REQUEST FOR INFORMATION (RFI)

PROJECT :	BKK2	R.F.I. NO. :	523213-01-RFI-AR-0025
TO :	CTA	ATTENTION :	CTA
SUBMITTED DATE:	19-Jan-26	NEED REPLY BY DATE :	26-Jan-26

SUBMISSION OF :	<input checked="" type="checkbox"/> Q&A	<input checked="" type="checkbox"/> Drawing	<input type="checkbox"/> Document	<input type="checkbox"/> Others (as specified below)
SUBJECT : Request for Information - Confirm for the Final Height of HMI Display from Fan Wall unit (FWU) with Respects to Human Ratio.

DRAWING NUMBER	523213 - 02 - DRG - AR-3316

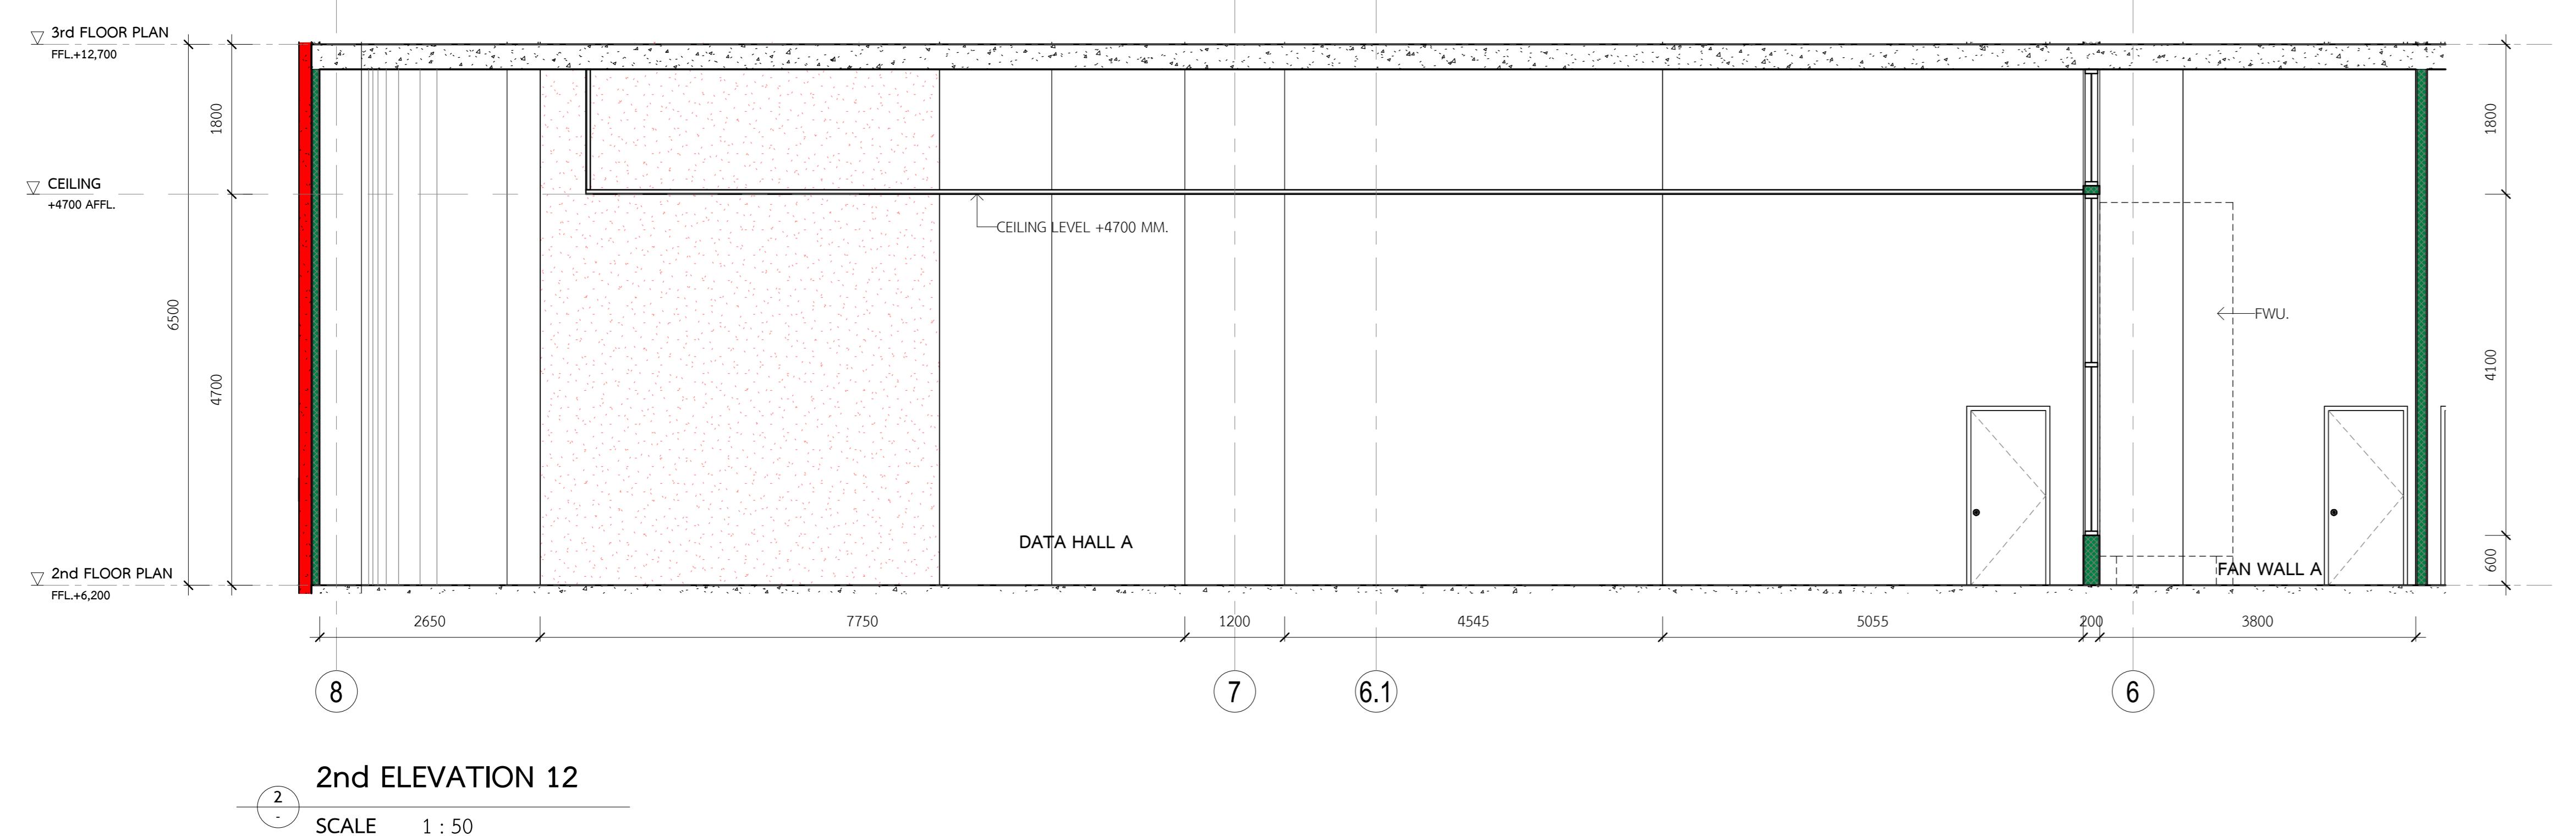
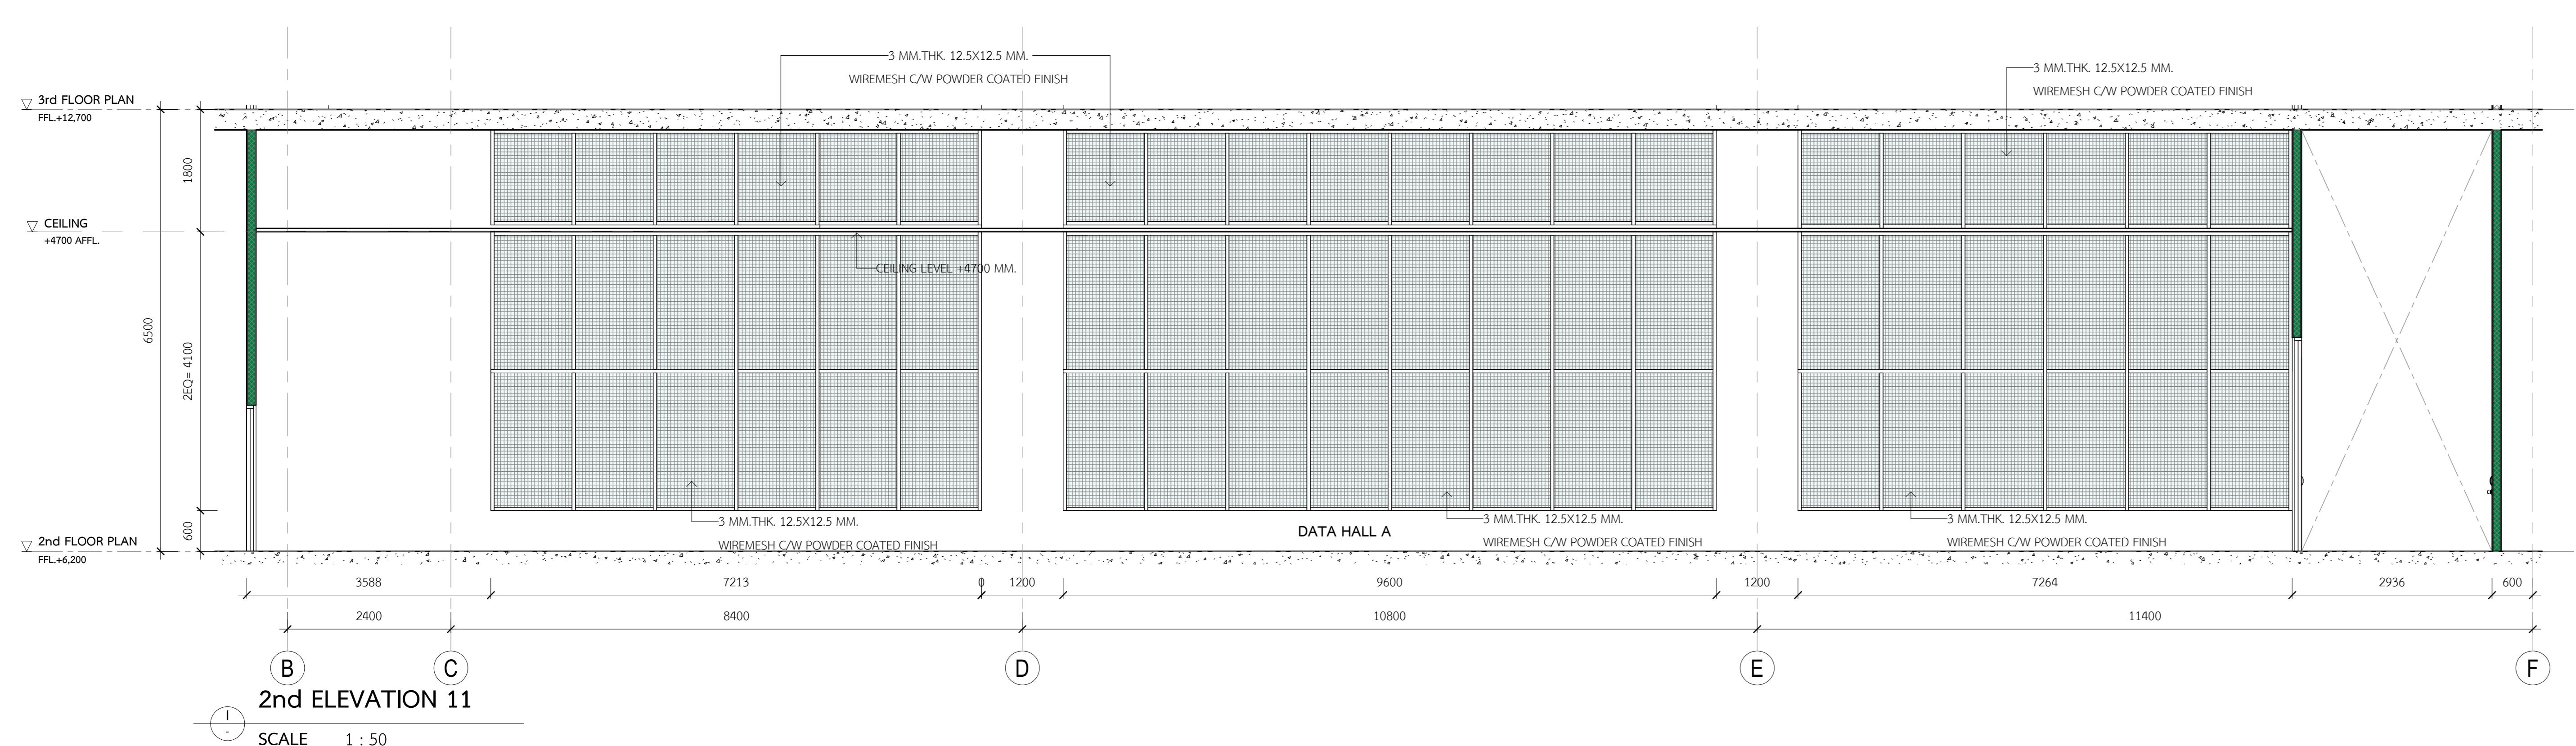
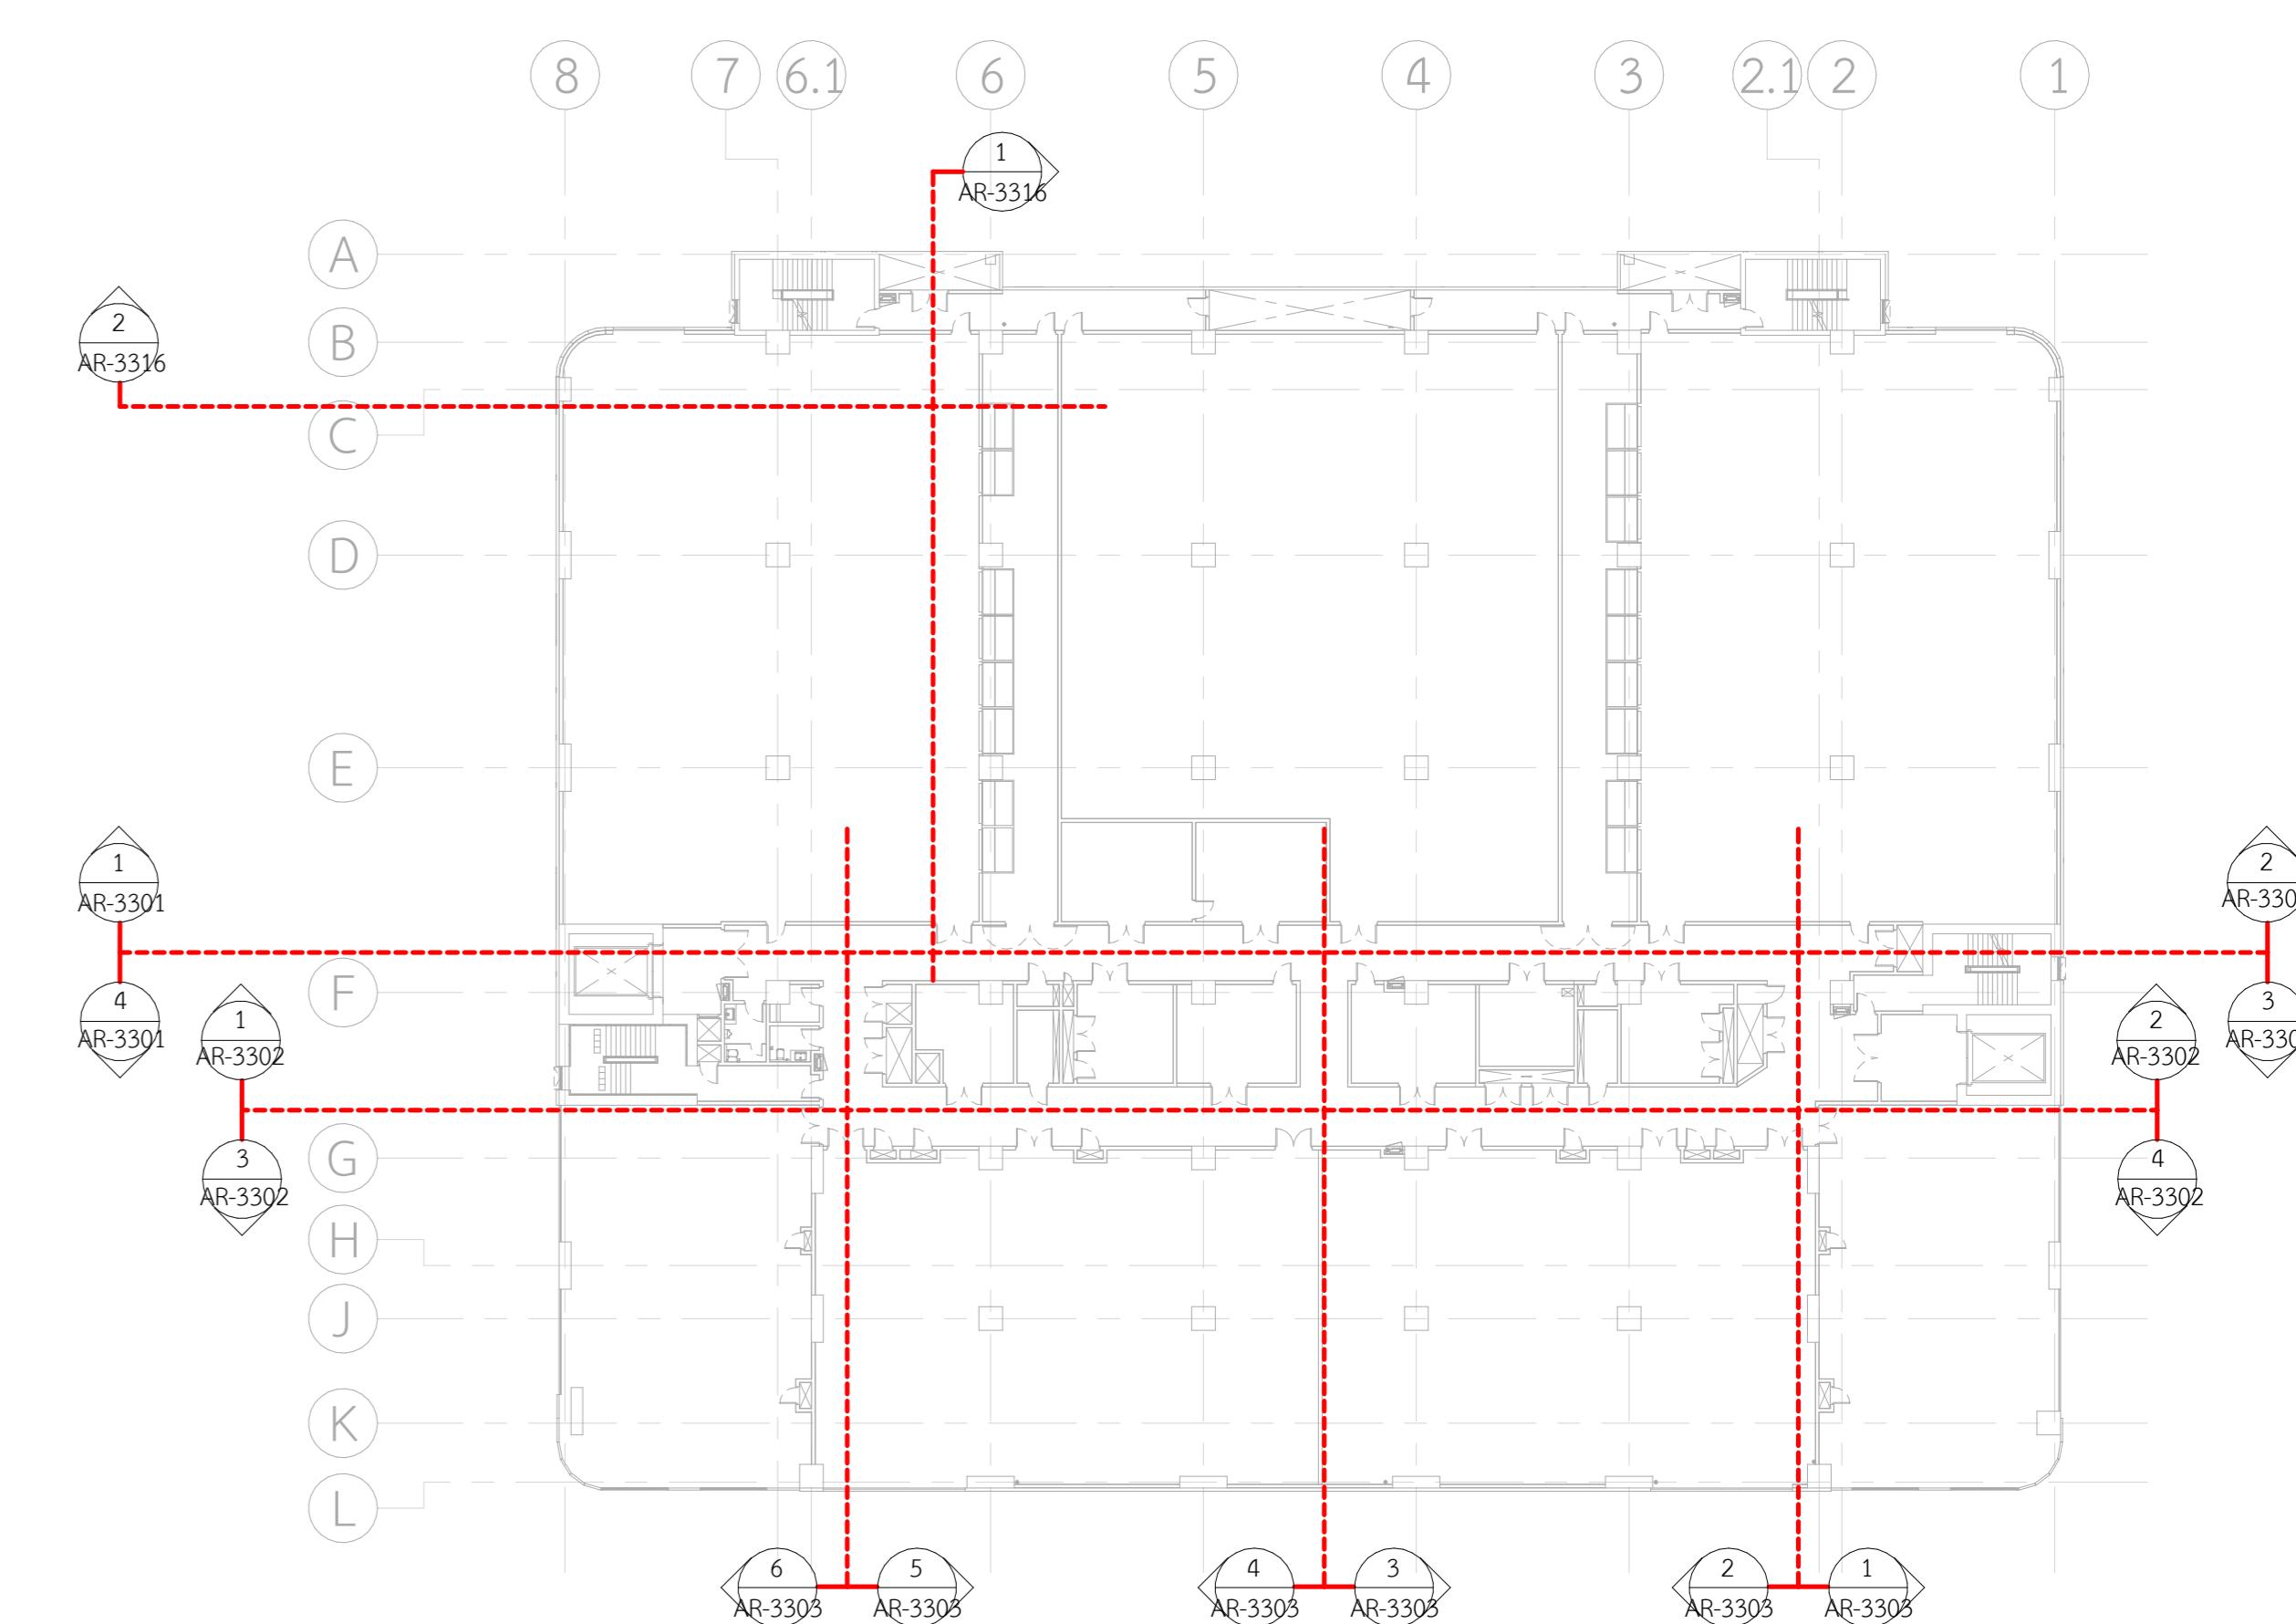
SLA: Please refer to the notes in the attached markup.

The height from consultant's response is for guideline. However, the location of HMI relates
to service and maintenance issue. Contractor shall come back with more propose section view
to demonstrate when operator stand on ladder step.
